**ADDENDUM NO. 1
FEBRUARY 26TH, 2026**

PROJECT: ANSON ISD
ELEMENTARY & HIGH SCHOOL CLASSROOM ADDITION

BID DATE: MARCH 5TH, 2026

SCALE: 1/2" = 1'-0"

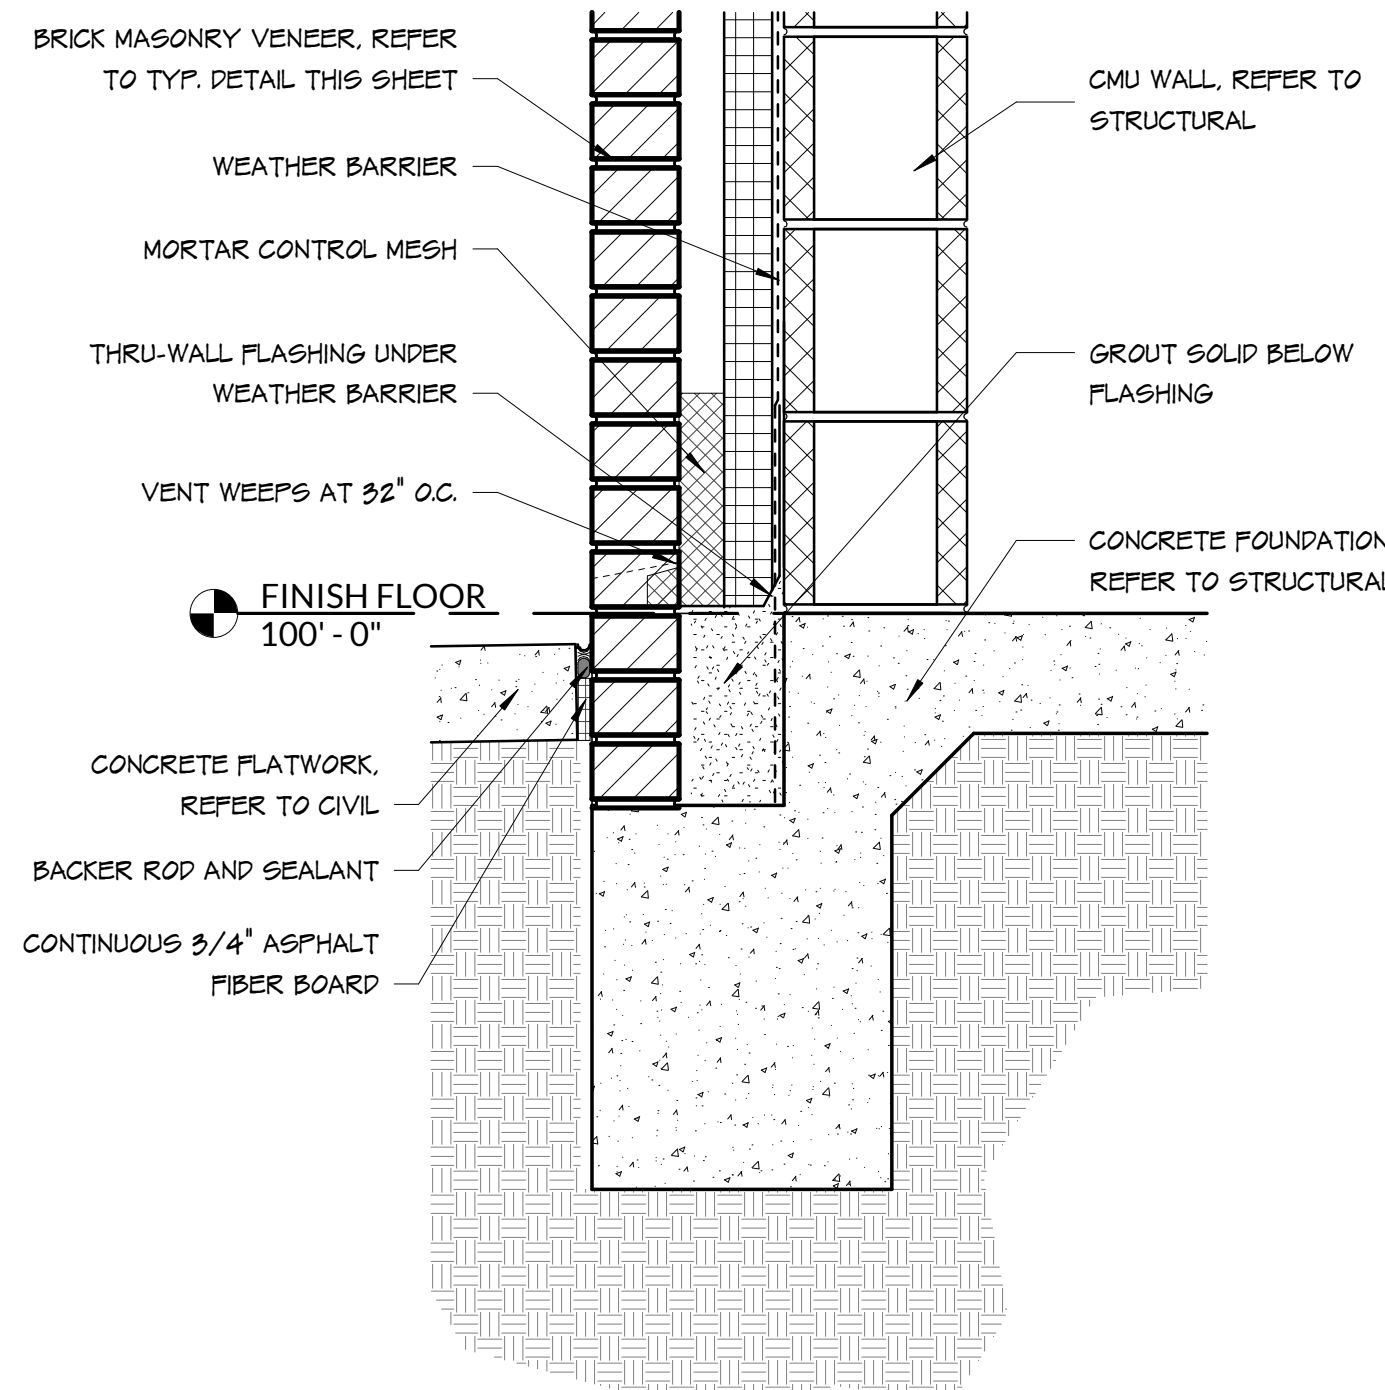
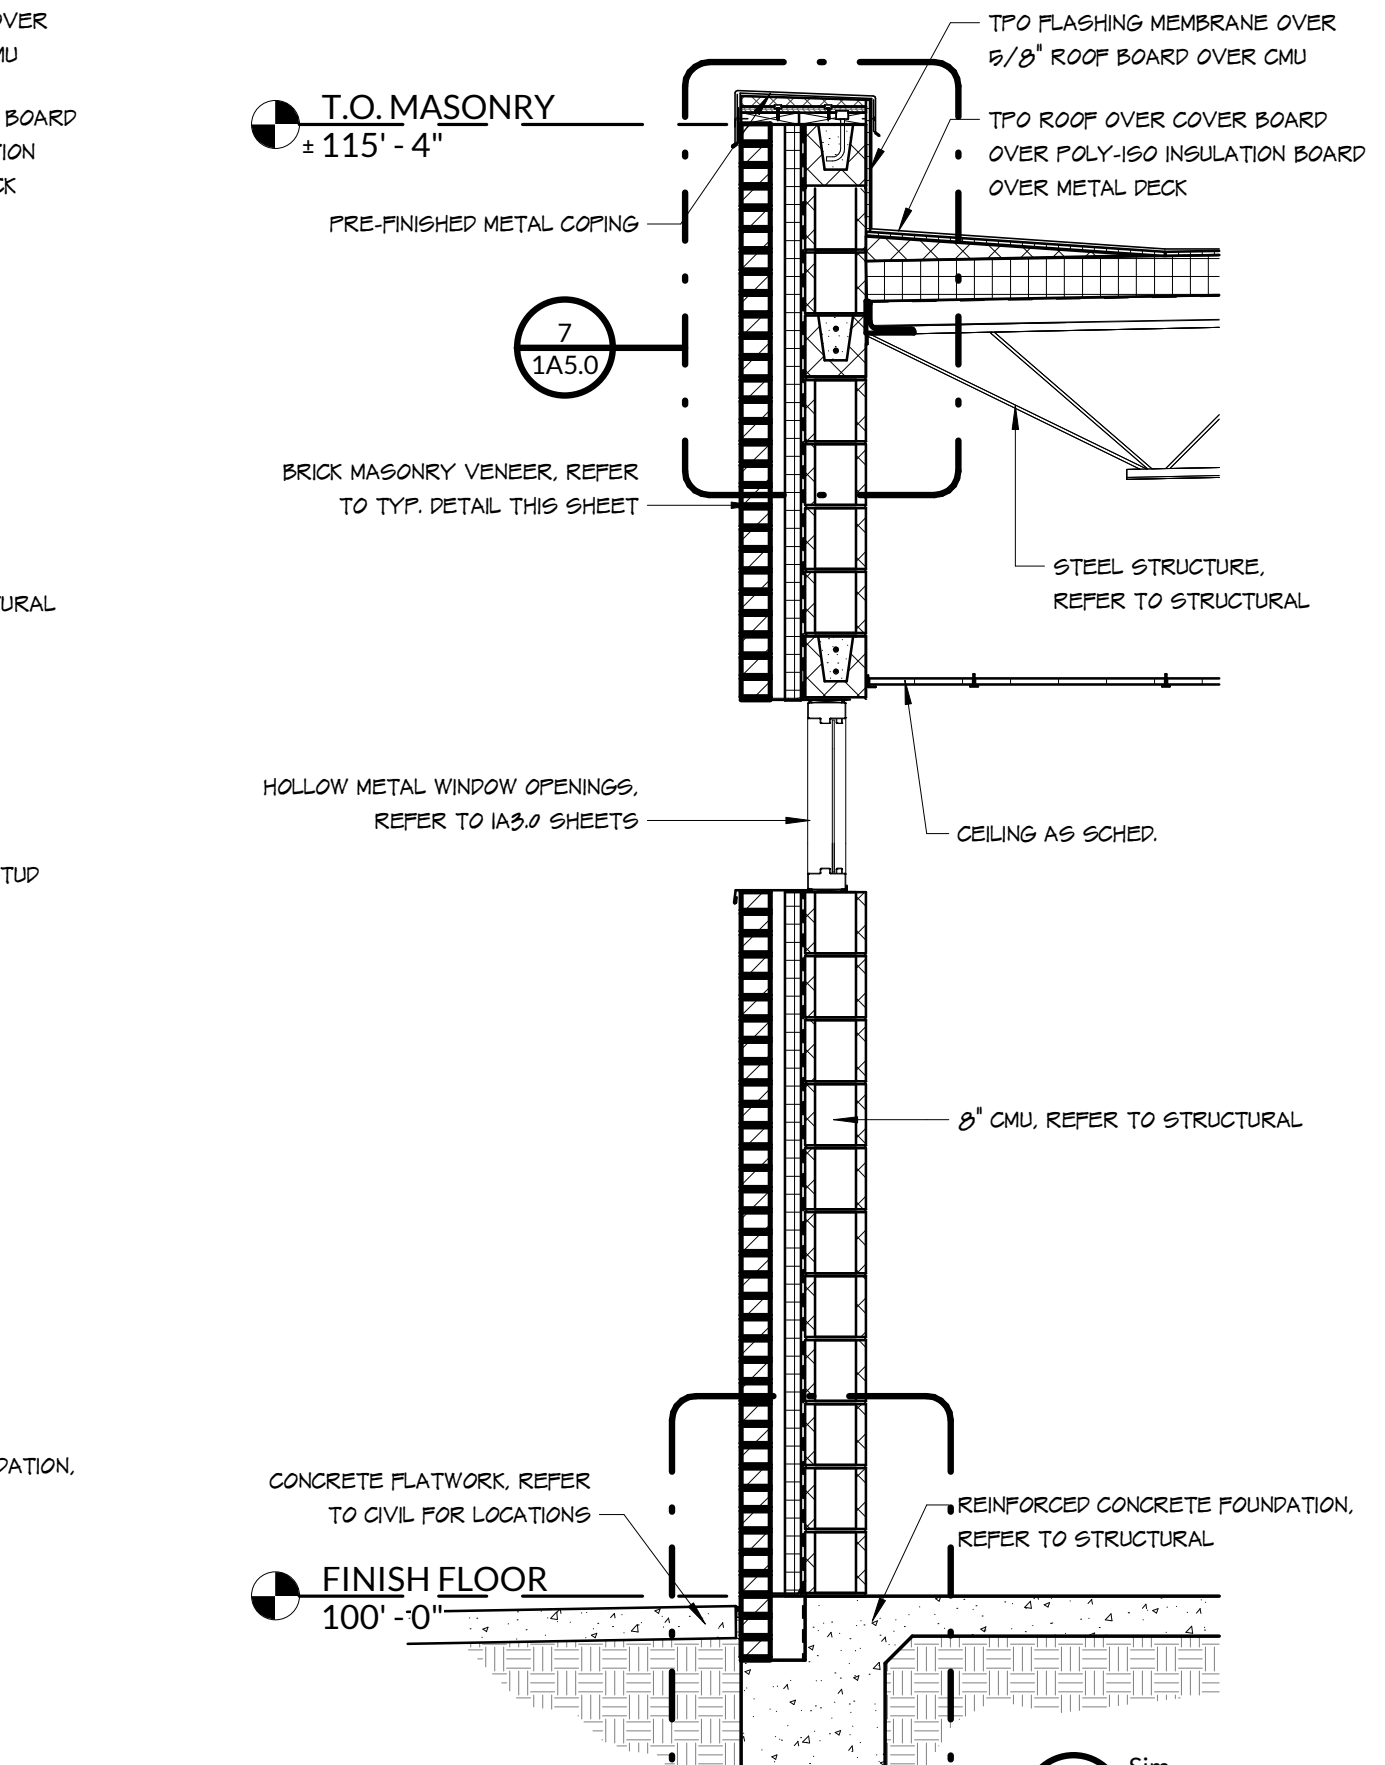
- Item #D1** **Sheet 1A2.1** – REPLACE sheet with attached sheet 1A2.1 dated 02-26-2026. UPDATED room finish schedule ceiling heights.
- Item #D2** **Sheet 1A5.0** – REPLACE sheet with attached sheet 1A5.0 dated 02-26-2026. UPDATED wall sections showing raised top of steel & lowered ceiling heights.
- Item #D3** **Sheet 1A7.0** – REPLACE sheet with attached sheet 1A7.0 dated 02-26-2026. UPDATED reflected ceiling plan with updated lighting layout in Vest. 100 & ceiling heights.
- Item #D4** **Sheet 1S1.0** – REPLACE sheet with attached sheet 1S1.0 dated 02-26-2026. UPDATED plan with missing non-load bearing CMU walls & added dimensions.

NO.	REVISION	DATE
1	ADDENDUM 1	02-26-2026
SEQ.	SHEET	
23320	1A7.0

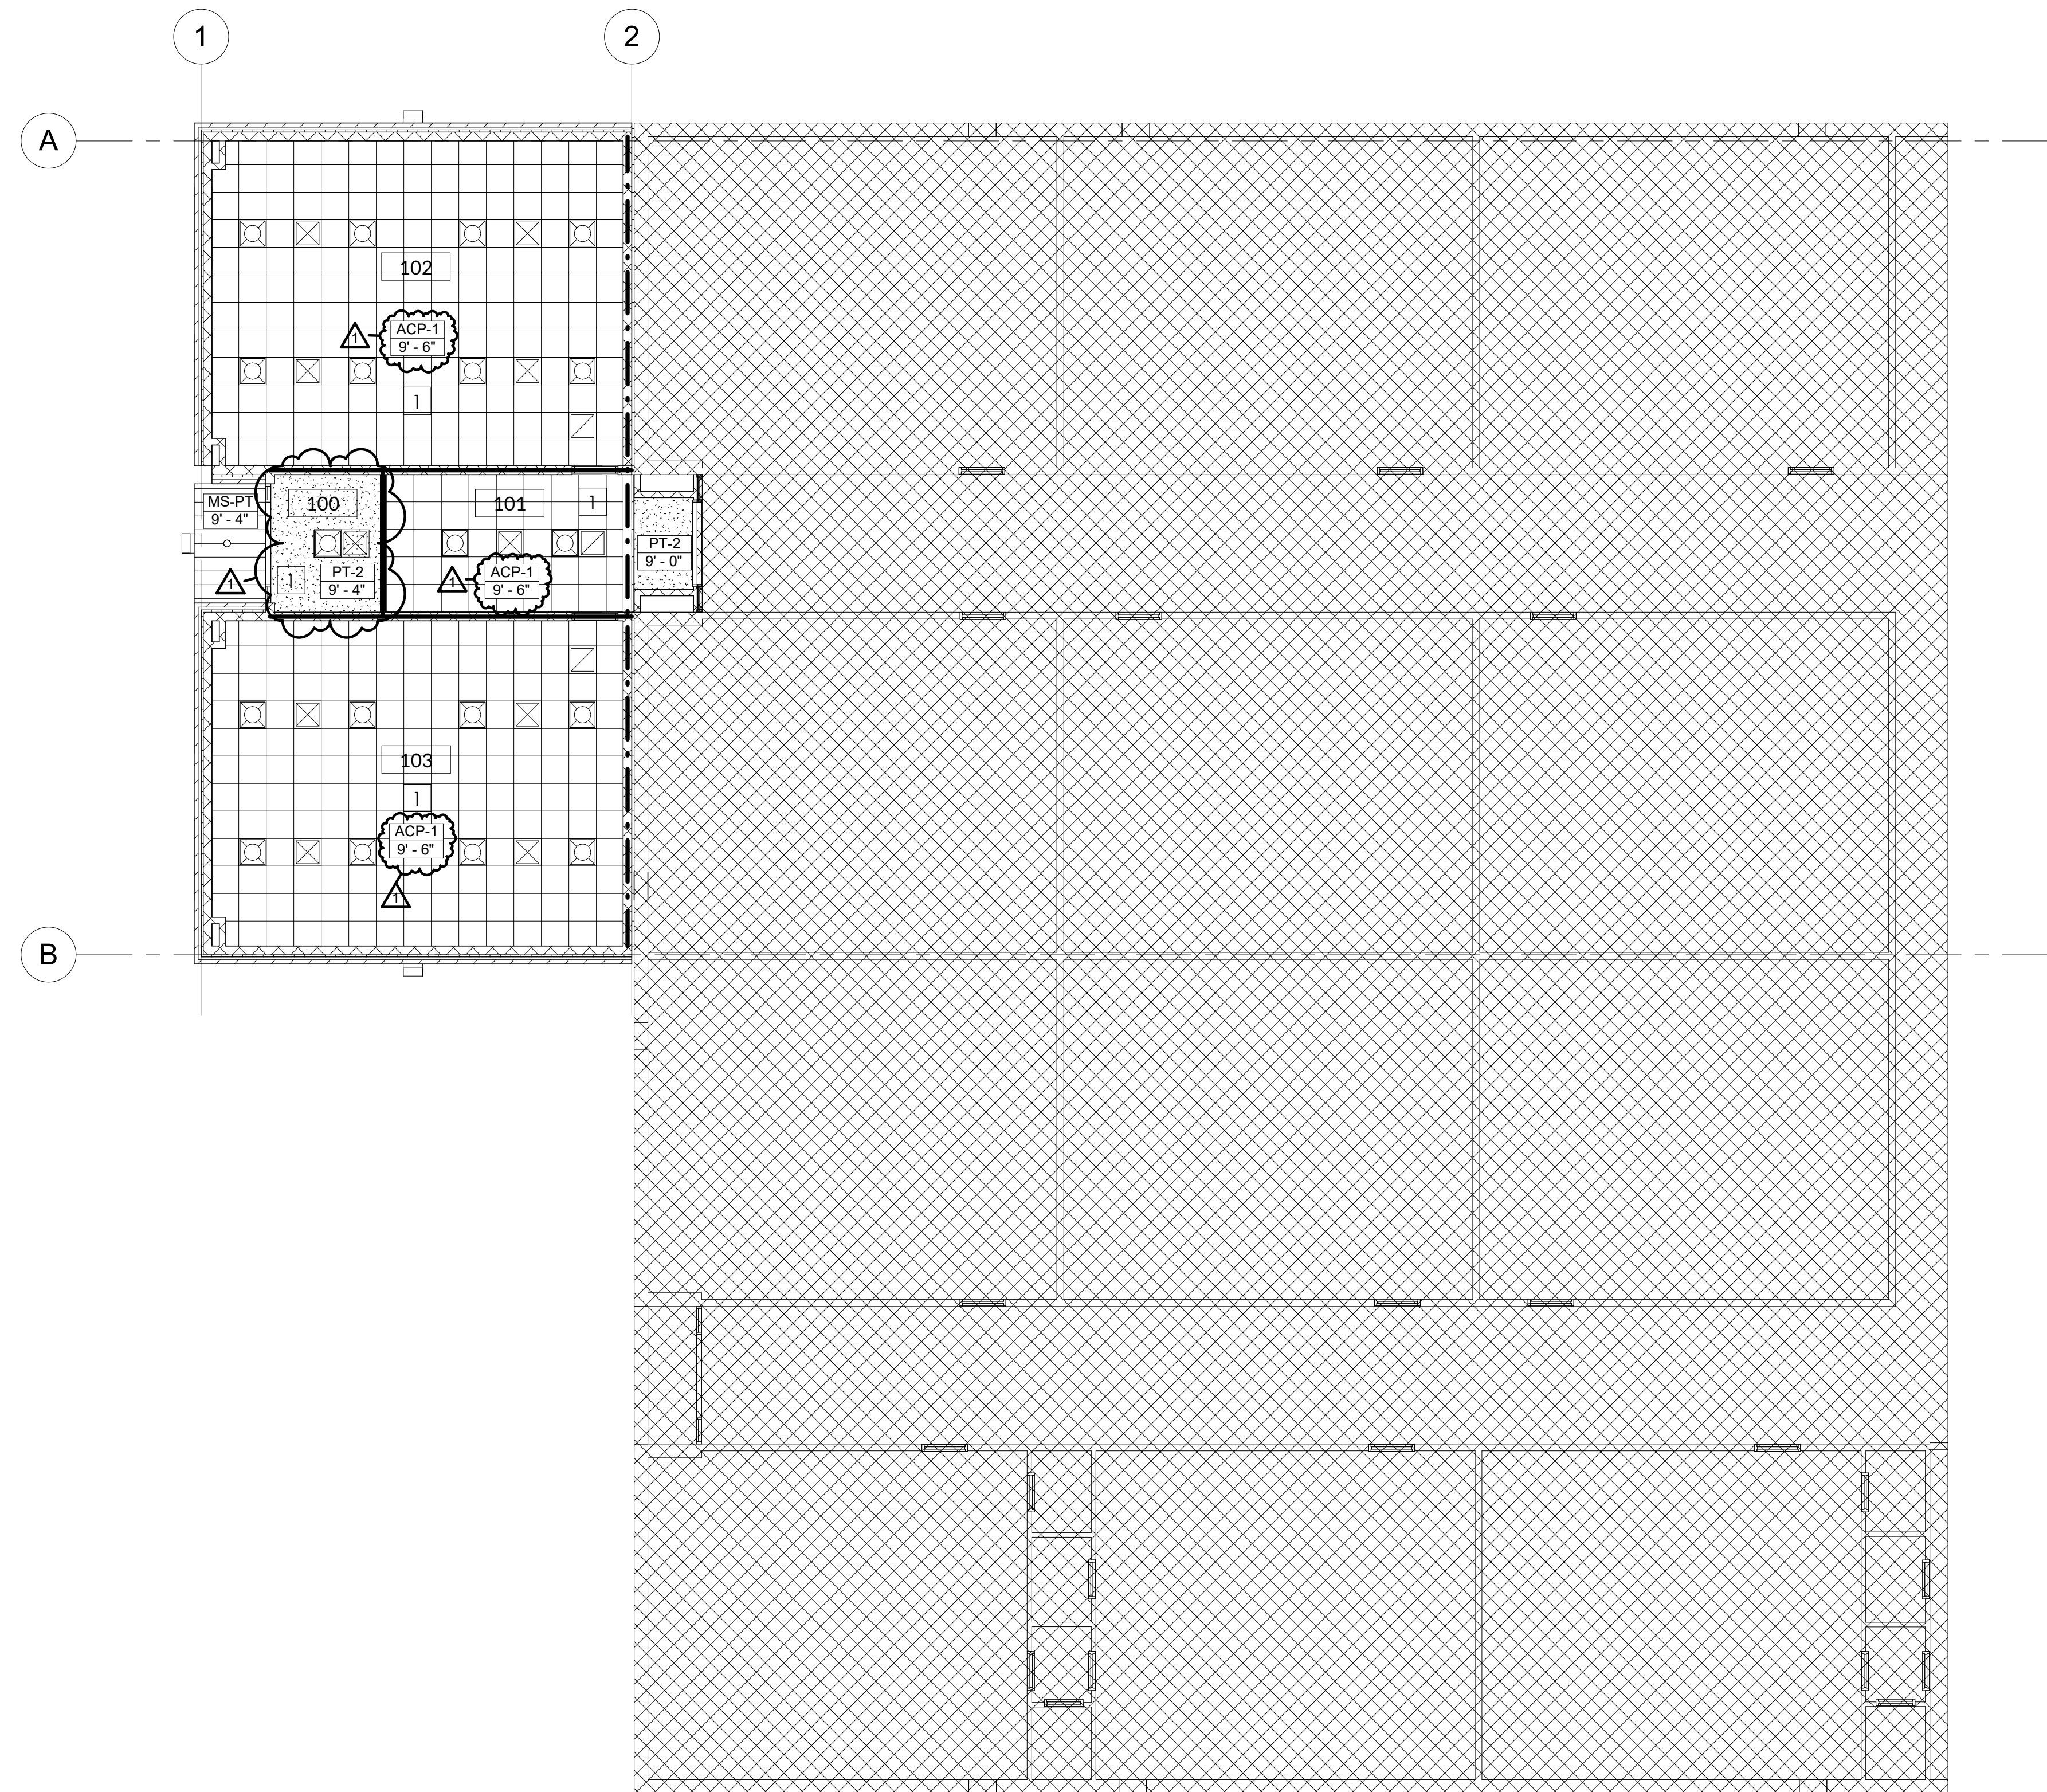
Item #Q1 **Question:** Is fire suppression required for these projects?

Item #Q6 **Question:** Will there be any fire protection drawings or specifications?

Answer: No fire suppression at either campus; existing fire alarm to be extended into both additions. See updated keyed note on RCP's.

Answer: New fire alarm devices to be connected to existing fire alarm system. Fire alarm plan to be designed by licensed fire alarm designer. See keyed note on RCP's.

- 1 NEW FIRE ALARM DEVICES TO BE CONNECTED TO EXISTING FIRE ALARM SYSTEM. FIRE ALARM SUB TO INSTALL DEVICES PLUS PULL CABLING AND MAKE CONNECTIONS. FIRE ALARM PLAN TO BE DESIGNED BY LICENSED FIRE ALARM DESIGNER.
